PRODUCT CHANGE | FLAT BOTTOM RAIL END CAP

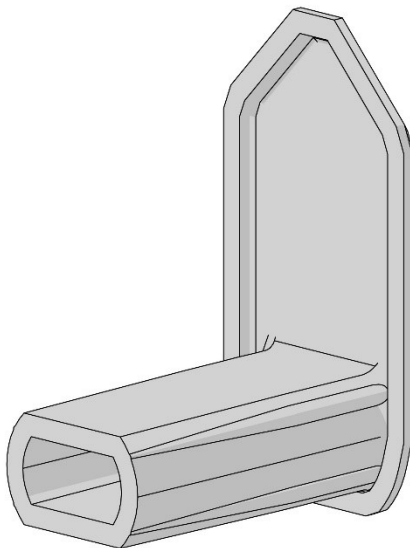
- Fitment ribs added to improve engagement into extrusion.
